TSG RAN Meeting #15   **RP-020039**

Title: **CRs (Rel-5) for WI "Technical Enhancements and Improvements"**

Source: **TSG RAN WG4**

Figure 6.4: Transmit template during TFC change

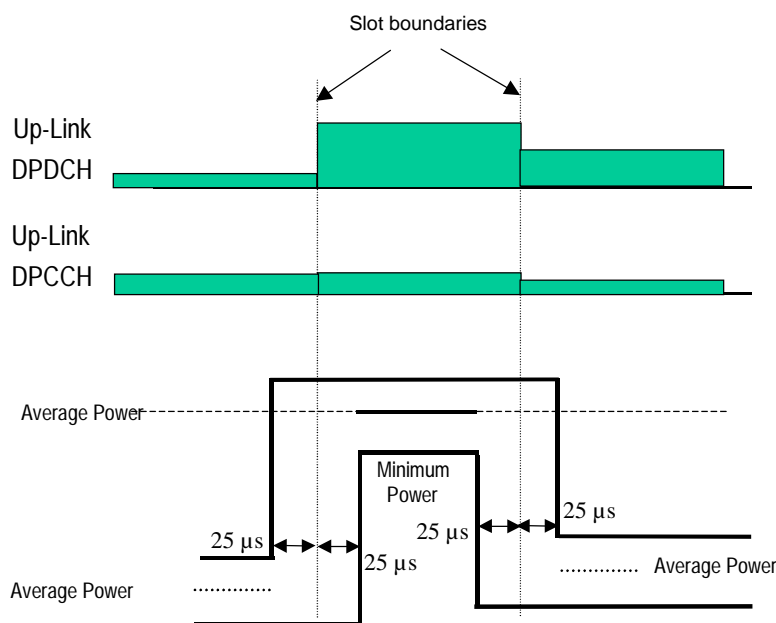
Reason for change: ⌘	Current description is not correct. When voice, user or control information is not present, only the "DPDCH" is turned off, not "DPCH", and the "DPCCH" which consists of TPC, TFCI, FBI and PILOT bits is always turned on.
Summary of change: ⌘	Editorial corrections to section 6.5.3. The word of "DPCH" changes to "DPDCH".
Consequences if not approved: ⌘	It might cause misunderstanding to specification.

A change of TFC (Transport Format Combination) in uplink means that the power in the uplink varies according to the change in data rate. DTX, where the DP<u>D</u>CH is turned off, is a special case of variable data, which is used to minimise the interference between UE(s) by reducing the UE transmit power when voice, user or control information is not present.

Figure 6.2

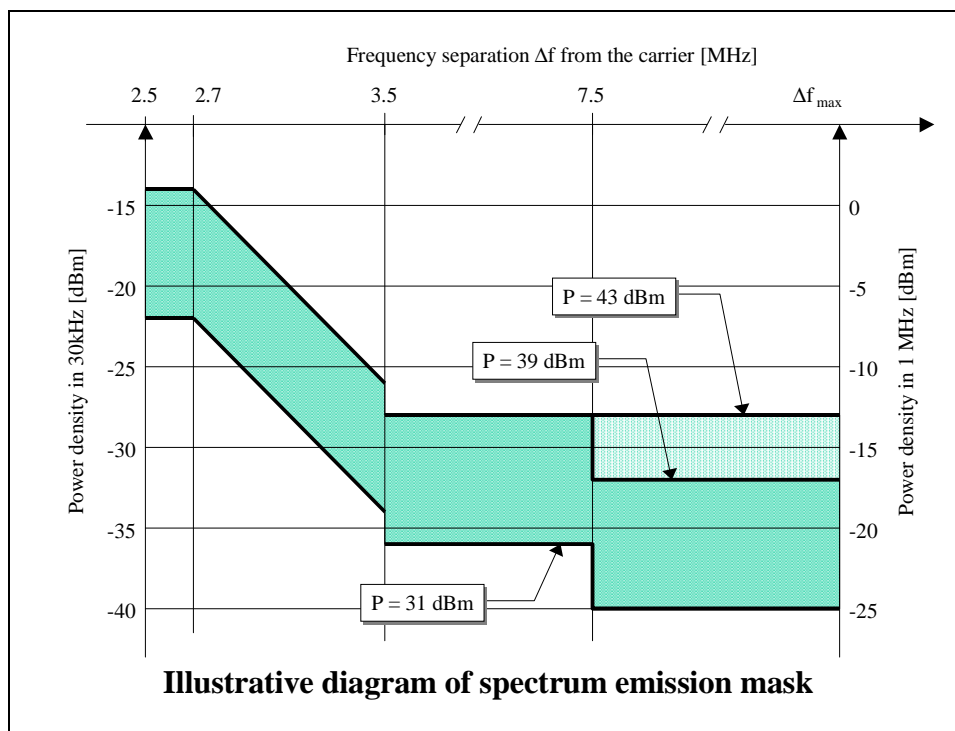
Reason for change: ✼	The formula for calculating the spectrum emission mask minimum requirement results in a negative answer, some units defining the range of Δf are missing and the upper limit for Δf is missing.
Summary of change: ✼	The correct units are used. The upper limit for Δf is added (Δf_{max}).
Consequences if not approved: ✼	The requirement is incorrectly specified leading to potential problems with Spectrum Emission Mask interpretation.

- Δf is the separation between the carrier frequency and the nominal -3dB point of the measuring filter closest to the carrier frequency.

- Δf_{max} is equal to f_offset$_{max}$ minus half of the bandwidth of the mesurement filter.
